## PROPOSAL REQUEST

**Government Center Envelope**

Proposal Request number: 07

## PCO #7

Attachments: Revised sheet S-102

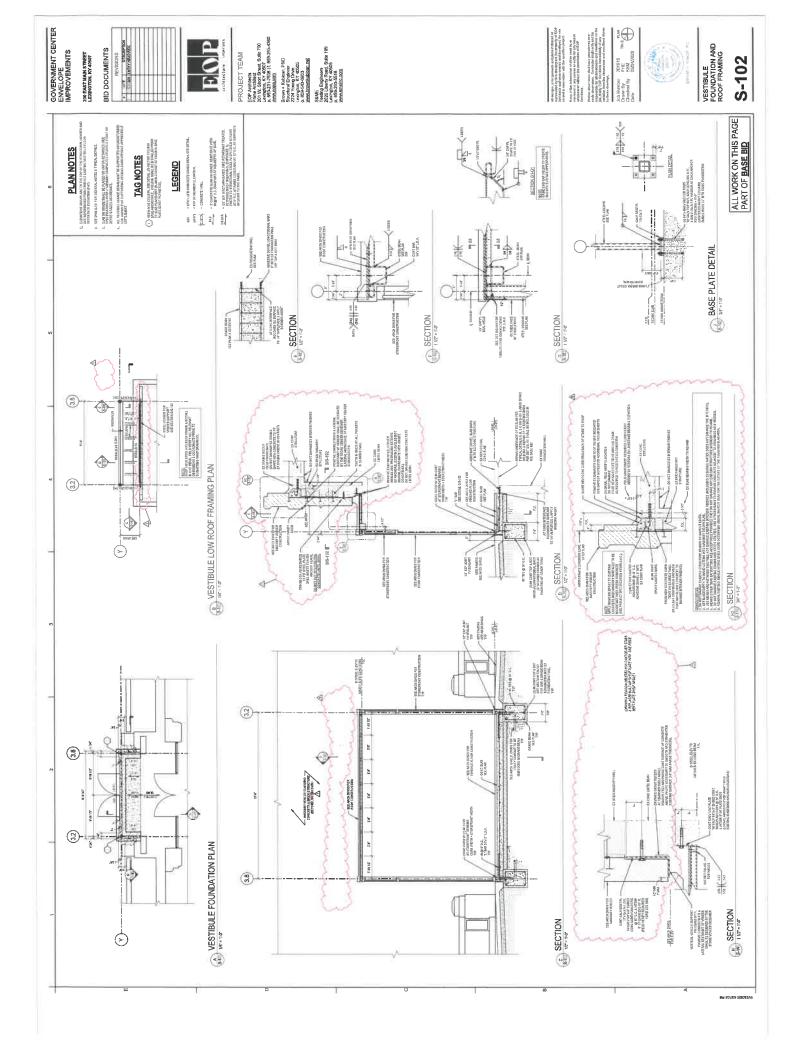
Existing conditions that were previously unable to be viewed have been uncovered by SSRG at the front vestibule during removal of façade limestone. This has exposed an existing concrete lintel above the storefront head in passable condition, brick masonry infill above this, and highly deteriorated concrete at the slab forming the roof of the existing vestibule.

Because of these existing conditions, some support conditions have been modified in the structural drawings to more closely match the actual substrate at these locations. Supports included in the project for attachment of a future canopy have been removed, since the new design will allow attachment at any point immediately above the new vestibule for a new canopy. Additionally, the design team has determined that the edge of the concrete slab must be removed and repoured.

Please provide the change to the contract sum and contract time, if any, for the scope changes related to these front vestibule found conditions. Provide breakdown for materials and labor for all separate trades/scopes of work. The work includes, but is not limited to, the following. See revised structural drawing S-102 for full description of structural changes.

- Removal of outer wythe of brick substrate at locations where 4" limestone had been used in lieu of 8" limestone
- Reconfiguration of limestone lintel bent plate and new vestibule roof connection. A version of this connection has already been shown in the bid documents, but has been revised in the attached sheet S-102 to reflect existing conditions.

- Routing or notching, where necessary, back face of limestone at bottom row of limestone. Front face of limestone must remain in plane with existing limestone façade. Existing concrete lintel may not be bushhammered. As such, the back face of some limestone blocks in the lowest row of reconstructed limestone masonry may need to be notched in order to accommodate new bent plate. See revised detail H/S-102.

- Removal of steel attachment points for potential future canopy connection.
- Infilling existing holes or openings in brick masonry substrate with new brick masonry. This includes the uncovered beam pockets, and at least one outer wythe of brick where holes exist in the façade at the roof drains.

- Sawcutting existing slab edge where slab edge has been uncovered by limestone removal, and repouring new slab edge/curb. The intent is that this repair will only occur where the slab edge has been uncovered by work within the original scope of work. The two short sides of the slab are considered to be outside of the scope of work; the entire front edge of the slab is considered to be within the scope of work. Slab edge is to be repoured and anchored to existing as shown in revised sheet S-102. The intent is that the slab will not be cut back to such an extent that work on the slab will damage existing interior finishes. Contractor shall take care that all demolition and new work will not harm interior finishes.

- Any modifications necessary to limestone attachment hardware due to difference between found conditions and substrate condition assumed in bid documents.
